COMMON DRIVEWAY
Application for Special Permit *

Modification of

Re: Request for Amendment or Modification to the Common Driveway Special Permit dated April 8, 2015 (the "Special Permit") affecting that certain common driveway located at 147 Long Hill Road, Bolton, MA ("Property")

**RE: Long Hill Road Common Driveway
Bolton, MA**

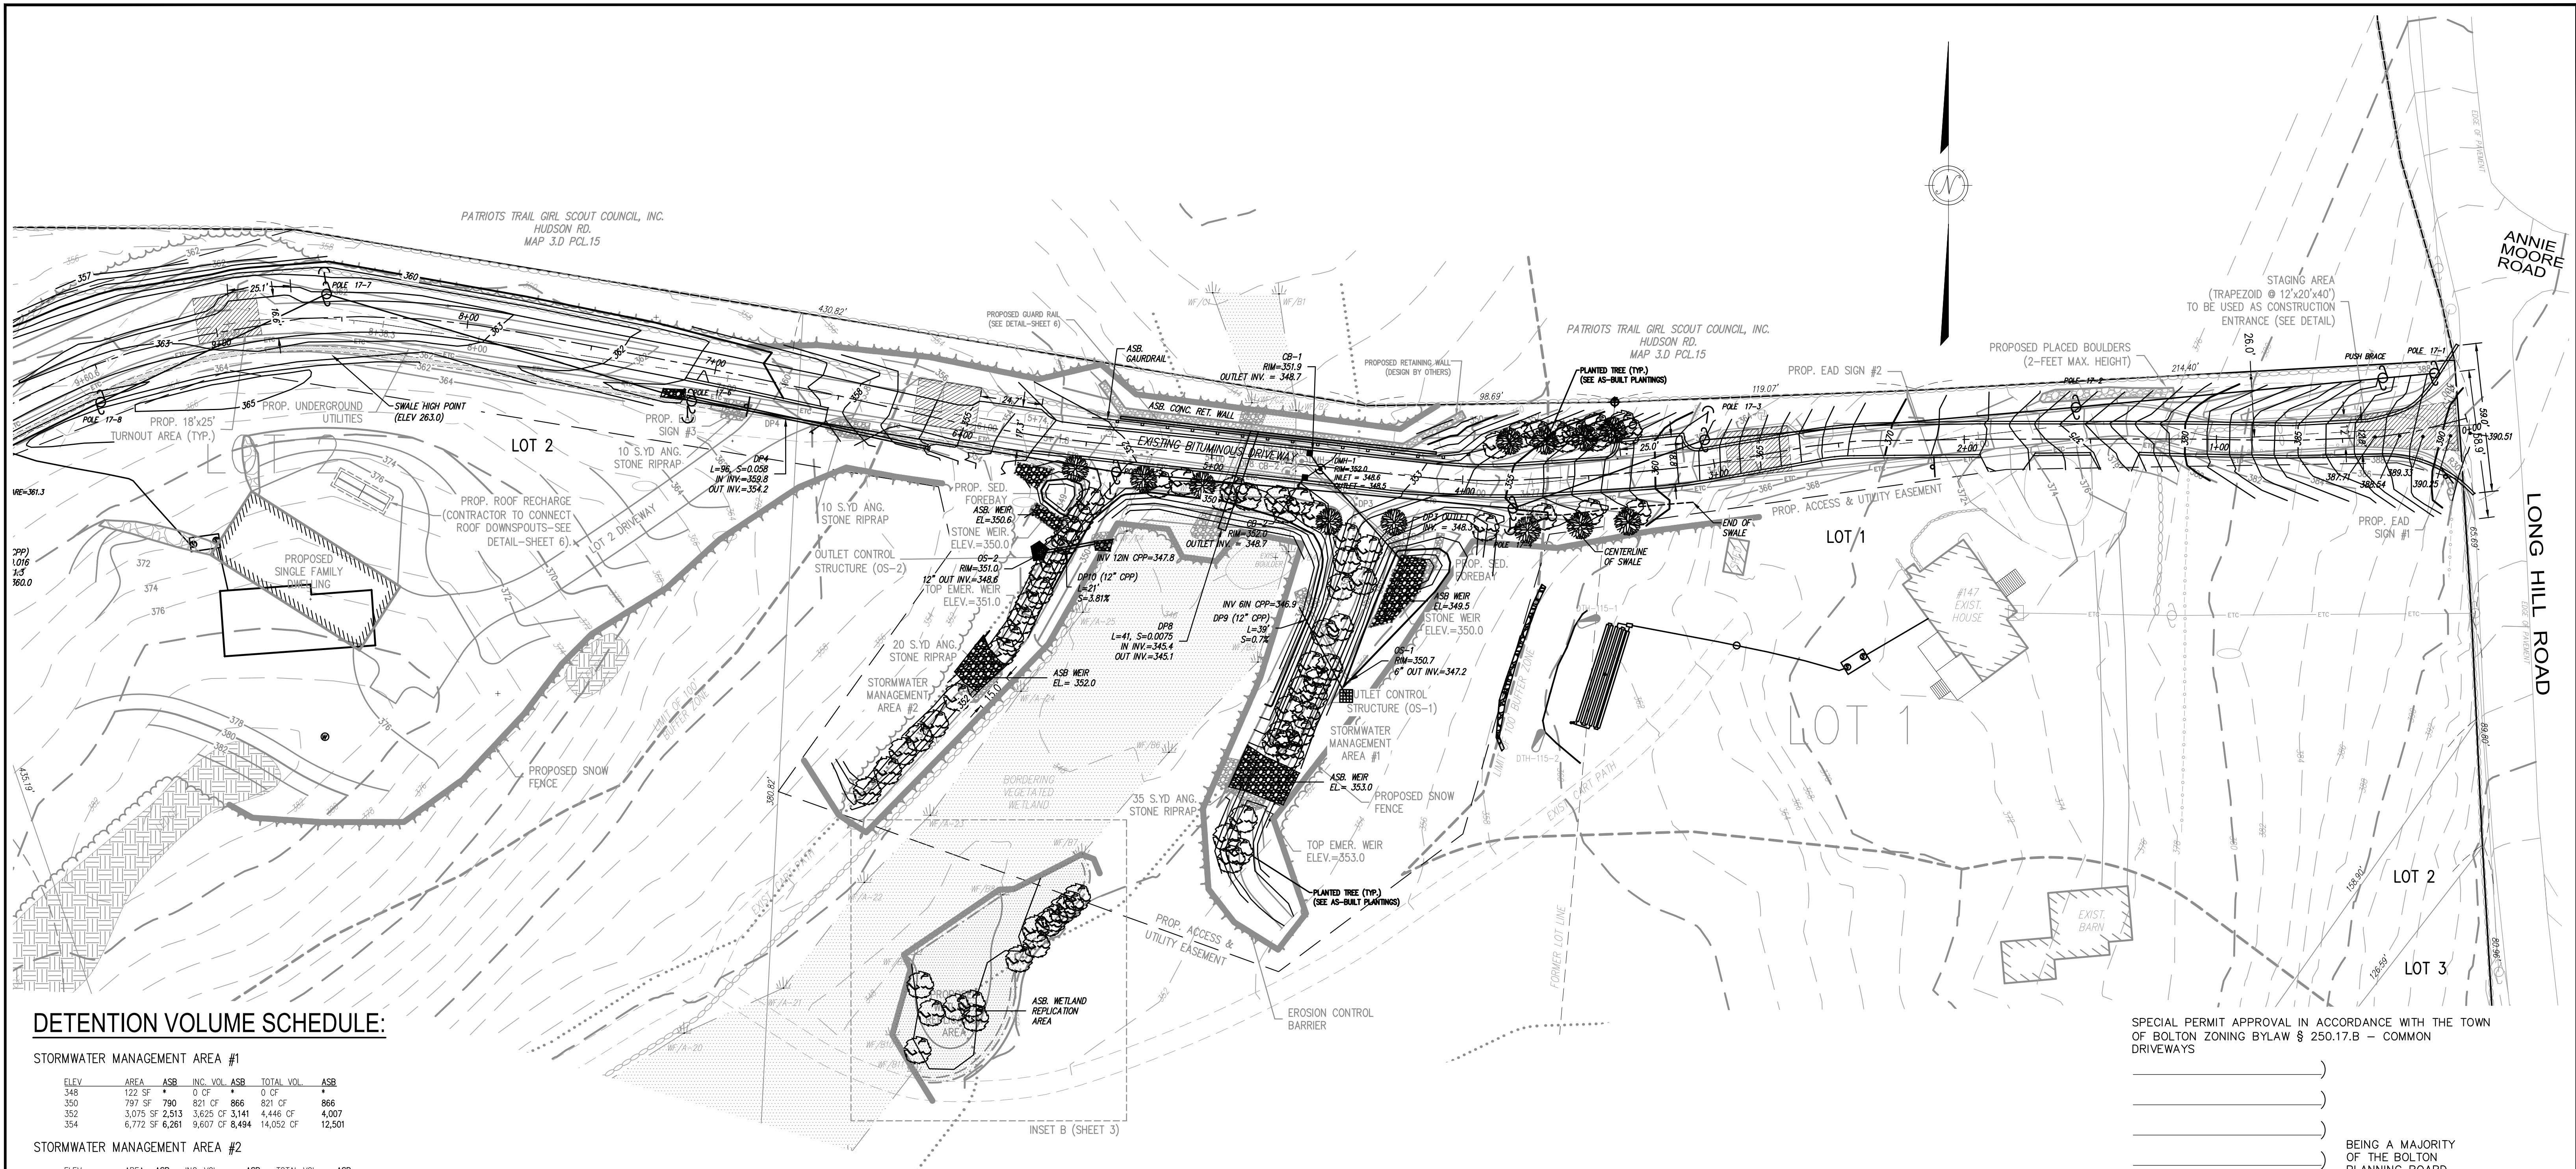
1. **Driveway slope at the entrance exceeds the required 4% max. grade within 40-feet of Long Hill Road.** The driveway slope at the entrance slightly exceeds the 4% max grade set forth in the original permit. In spite of this, as previously noted in our letter dated May 8, 2019, we note that this portion of the driveway appears to be functioning adequately and that the intent of the regulation is met.

2. **Driveway was not constructed with a crown as designed between stations 0+00 and 5+10.** This deviation was noted in our letter on May 8, 2019. Despite this deviation, it is our position that the driveway functions according to the original intent of the approved plans and that the existing, super-elevated design does not pose a safety or engineering concern. It is notable that super-elevated common driveway designs are permitted in the Town of Bolton and in fact, the majority of the common driveway in question was designed as a super-elevated driveway as is noted on the approved plans. In addition, in order to alleviate any excess water flow over the asphalt berm at station 3+50-3+75, at our recommendation and in conjunction with the Applicant's public meeting process subsequent to May 8, 2019, the Applicant installed a swale per our design, which swale has been noted on the final as-built. The swale, as constructed, is in conformance with our design and it is our belief that this swale will adequately mitigate any previously noted excess water flow.

3. **The first turnout begins at station 3+06 which exceeds the maximum 300-foot design spacing.** Despite the variation, as previously noted in our letter dated May 8, 2019, we note that the turnout location achieves the intent of the regulation allowing for vehicles to pass each other at regular intervals along the common driveway. In addition, as is noted on the final as-

4. **Turn out at Station 6+00 is approximately 24.7' x 17.3' where 25' x 18' is required by the Special Permit.** The existing turnout size is substantially consistent with the requirements of the Special Permit and achieves the intent of the regulation allowing for vehicles to pass each other.

5. **Turn out at Station 9 is approximately 25.1' x 16.6' where 25' x 18' is required by the Special Permit.** In spite of this, we note that the turnout size is substantially consistent with the requirements of the Special Permit and that it achieves the intent of the regulation allowing for vehicles to pass each other.

6. **Turn out at Station 12+00 – as constructed, this turn out is approximately 25' x 17.7' where 25' x 18' is required by the Special Permit.** In spite of this, we note that the turnout size is substantially consistent with the requirements of the Special Permit and that it achieves the intent of the regulation allowing for vehicles to pass each other.

We note that various other de minimis deviations have been noted from the approved plans to the final as-built, including but not limited to the height and caliper of certain plantings, as well as the swale size at stations 3+00 to 4+00. We note that these are not regulatory deviations and that they do not impact the safety or functionality of the common driveway. Accordingly, it is our opinion that these deviations are insubstantial and permissible.
